Subject: **Redesign Pit 10 Sump, Alton Coal Development, LLC, Coal Hollow Mine, Kane County, Utah, C/025/0005**

Alton Coal Development, LLC (ACD) is submitting the attached update for Drawing 5-3C. The northern highwall is failing into the current sump so ACD needs to re-dig the sump to maintain specification capacity.

**Title:** Redesign Pit 10 Sump

<b>UNDERGROUND FACILITIES &amp; STRUCTURES</b>	
<b>DESIGN LAYOUT</b>	
COAL HOLLOW PROJECT ALTON, UTAH	
<b>DRAWING: 5-3C</b>

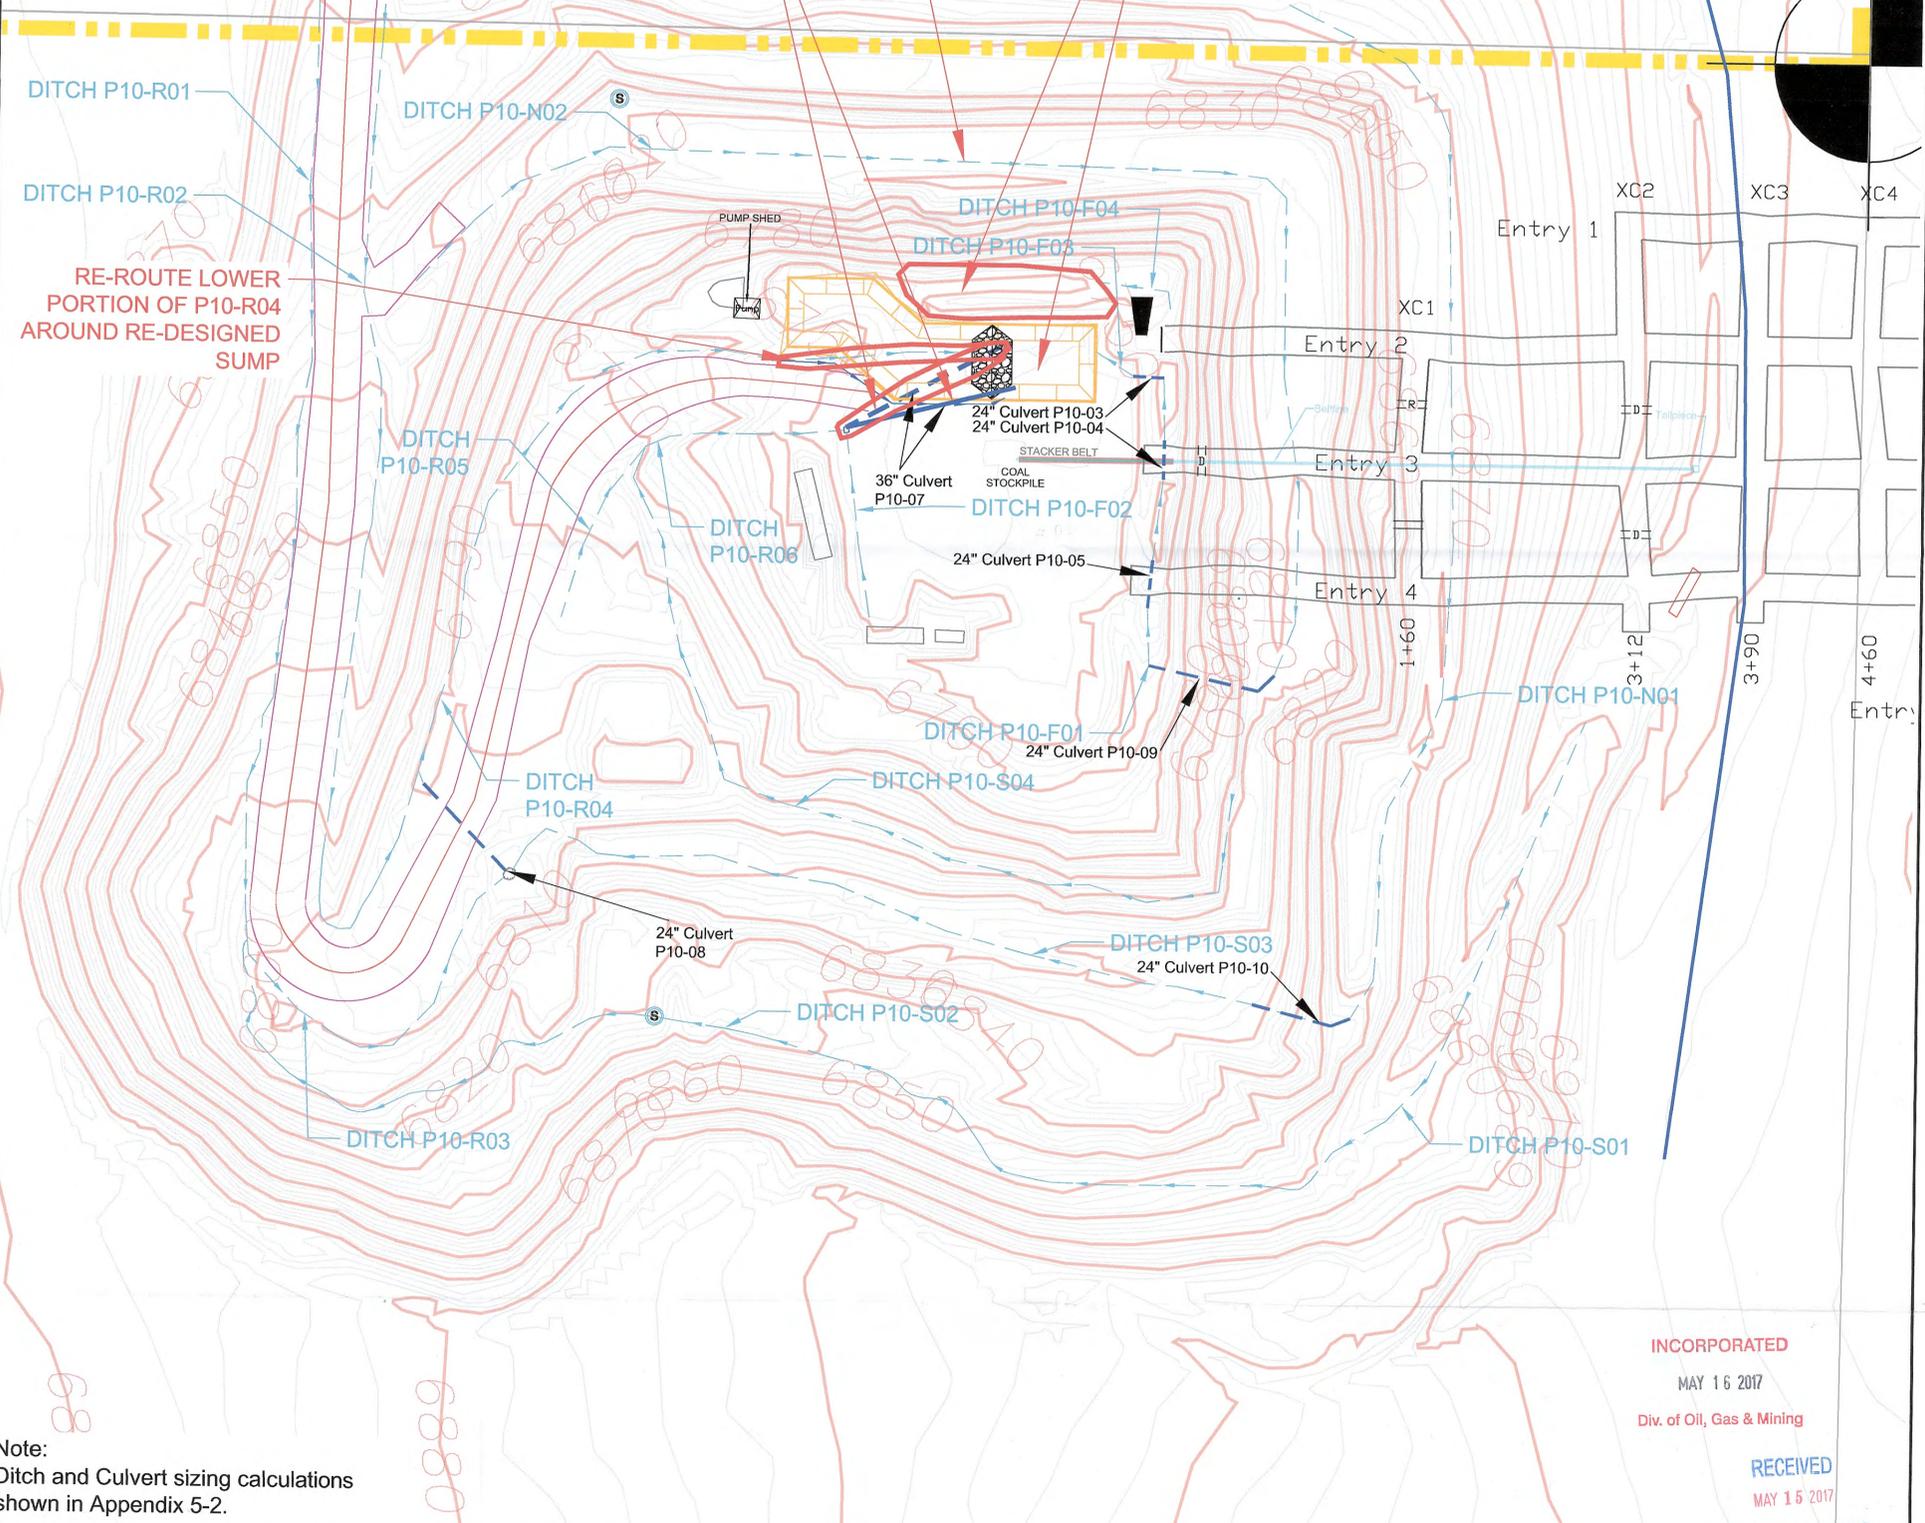
RE-ESTABLISH P10-N02 ON BENCH ABOVE FAILING HIGHWALL WHEN SAFE

RE-DIG SUMP SOUTH OF FAILING HIGHWALL TOE MINIMUM SUMP TOTAL CAPACITY = 1.5 AC-FT @ 10' DEPTH, 1H:1V INCISED SLOPES & USING GRAVEL DIKE TO FILTER WATER FROM EAST TO WEST.

RELOCATE 36" CULVERT P10-07 & CLEAN OUT INLET DROP BOX

RE-ROUTE LOWER PORTION OF P10-R04 AROUND RE-DESIGNED SUMP
